**YAMAHA****MEASURE REPORT**

MODEL	TDR240/250, TZR250	FILE	
SUBJECT	PISTON MELTING AT CROWN

MODEL	TZR250 '87, '88	FILE	
SUBJECT	PISTON SEIZURE

MODEL	TZR250 '87, '88	FILE	
SUBJECT	PISTON RING BREAKAGE

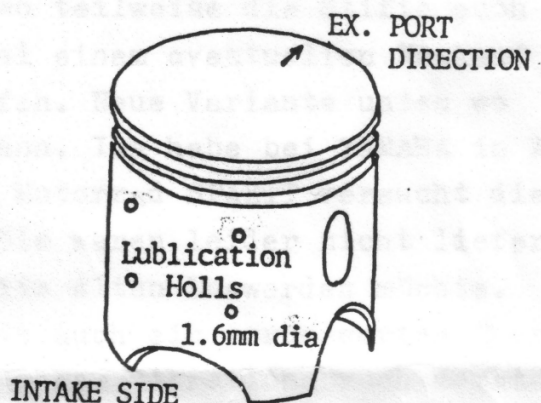
To prevent scaffing at early break-in, we are going to change the piston design as similure with 2YK type (TDR250) as a next model. The 2YK type piston has four location of lublication holls at intake side as shoun in the left. These holls will provide greater lublication effect between piston and cylinder wall comparison with present ones.

If you encounter a smilure problem, please recommend your dealer to use following part instead of STD ones. Recommended piston is as same as TDR250 model's one.

Alte Variante

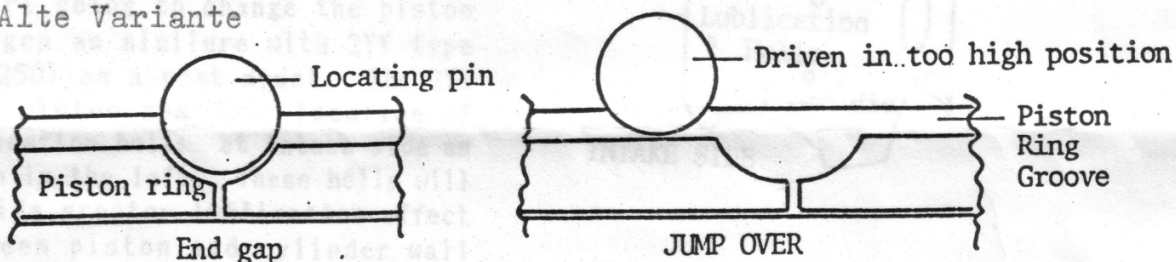
The piston ring located pin may be experienced driving into piston ring groove with insufficient dimension accuracy in some units (drivig upward comparison with specified location) . And also locating pin can be worn. These matter may cause that piston ring end gap can jump over the locating pin and then end gap will catch with cylinder ports. See below.

YZ TYPE LOCATING PIN

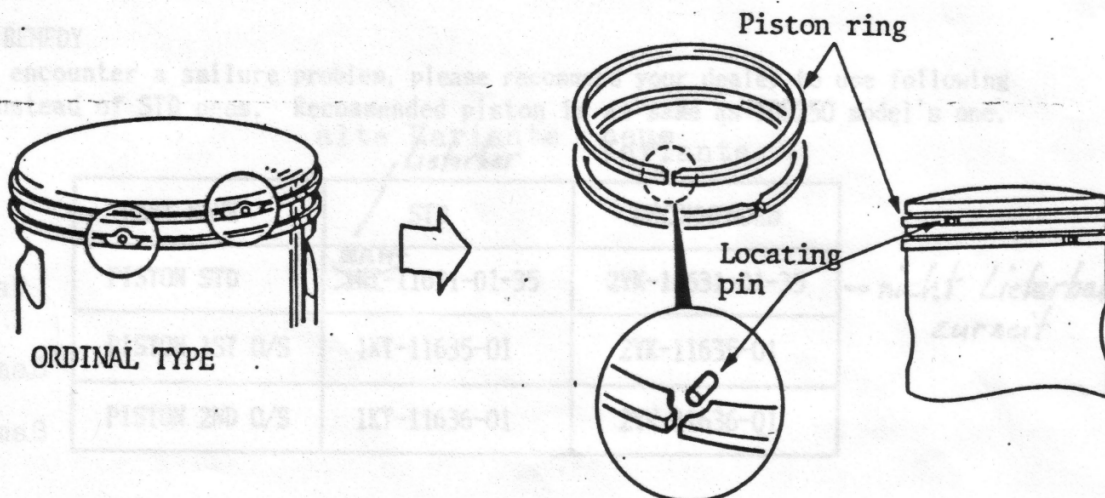
To prevent jumping over, locating method of piston ring will be changed to YZ type as shown in below. Now we are investigating this remedy to employ with next model.
